Nedsbar Forest Management Project EA Errata – August 4, 2016

The following is a list of minor errors we have discovered and associated corrections or clarifications to the environmental assessment (EA) for the Nedsbar Forest Management Project to date. Yellow highlights indicate where corrections have been made.

Figure 3-10. Post-treatment cumulative effects to spotted owl NRF habitat on BLM lands within the Nedsbar Analysis Area by action alternative.¹

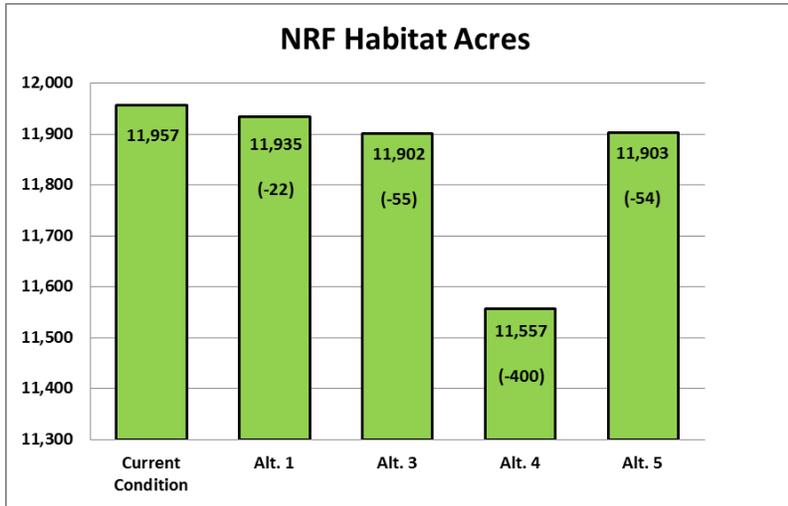
Habitat	Existing Environment	Alt. 1	Alt. 3	Alt. 4	Alt. 5
NRF	11,957	11,935 (- 0.18%)	11,902 (-0.46%)	11,557 (-3.4%)	11,902 (-0.46%) (11,903)
Dispersal Only	3,946	3,968 (+0.6%)	3,821 (-2.6%) (3,846) (-2.5%)	3,998 (+1.9%) (4,096) (+3.8%)	3,917 (-0.2%) (3,994) (+1.2%)
Capable	8,905	8,905 (0%)	9,063 (+1.8%) (9,060) (+1.7%)	9,231 (+3.7%) (9,155) (+2.8%)	8,967 (-0.7%) (8,911) (+0.07%)
Non-Habitat	3,425	3,425 (0%)	3,231 (-5.5%) (3,425) (0%)	2,980 (-13.4%) (3,425) (0%)	3,122 (-9.1%) (3,425) (0%)
Total	24,808 (28,233)	24,808 (28,233)	24,808 (28,233)	24,808 (28,233)	24,808 (28,233)

Figure 3-12. Post-Treatment cumulative effects to fisher denning/resting habitat on BLM lands within the Nedsbar Analysis Area by action alternative.¹

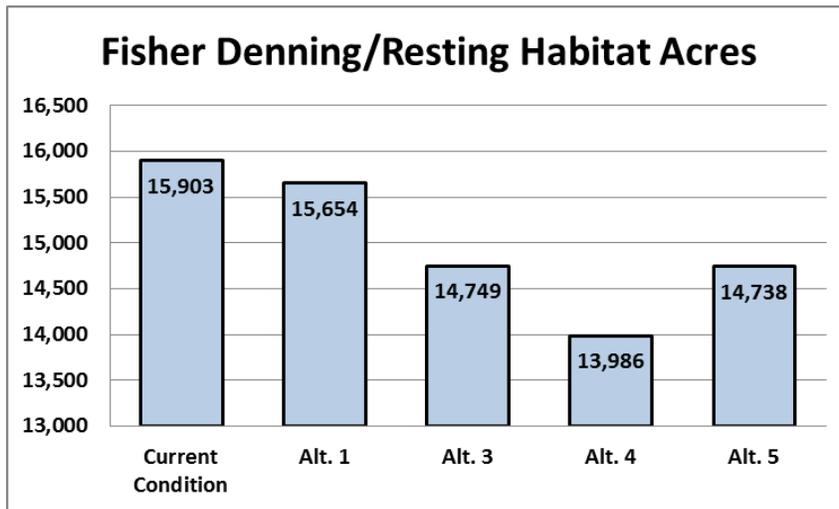
Under the No Action Alternative, thinning treatments proposed in existing projects with at least 40 percent canopy cover retention would reduce the quality of 15,654 (22) acres of suitable denning and resting habitat due to the reduced canopy cover. Table 3-39 below cumulatively adds the future foreseeable actions that would occur regardless of the Nedsbar project, to each Action Alternative. Figure 3-12 shows the total reduction of denning and resting habitat in the Analysis Area from each action alternative.

Alternative	Denning/Resting Habitat Remove	Denning/Resting Habitat Reduced Quality (Canopy cover 40-60%)	Denning/Resting Habitat Treat and Maintain	Total Habitat Proposed for Treatment	Denning/Resting No treatment
1	0	22	227	249	15,654 (-1.6%) (98%)
3	158 (155)	0 (22)	747 (977)	1,057 (1,154)	14,597 (-5.8%) 14,749 (93%)
4	326 (250)	269 (291)	1,073 (1,376)	1,668 (1,917)	13,986 (-9.0%) 13,986 (88%)
5	59 (6)	30 (52)	849 (1,107)	938 (1,165)	14,716 (-3.0%) 14,738 (93%)
